# M1659: PAN AMERICA FUEL TANK UPDATE

# **Purpose for Service Bulletin**

This bulletin informs dealers that the 2024 Pan America vehicles have been updated to have the inside of the fuel tank e-coated.

Figure 1. Screw Drain Plug

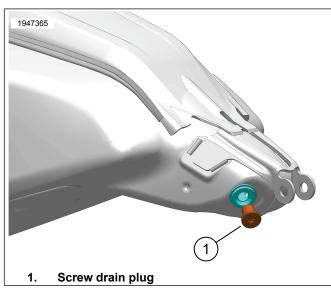
- To accommodate this process, a threaded plug (Part No. 10500167) was added to the left rear of the fuel tank.
- When ordering replacement fuel tanks for 2021-2023 vehicles, they will come with the e-coat process.
- Dealers will need to order and install the threaded plug (Part No. 10500167) separately.
- · Electronic Parts Catalogs are updated to reflect this information.

When ordering replacement fuel tanks for 2021-2023 Pan America vehicles, they will come non e-coated. Once old stock is depleted, all replacement tanks will come e-coated and dealers will need to order (Part No. 10500167) separately. Upgrading to new fuel tank is not warrantable.
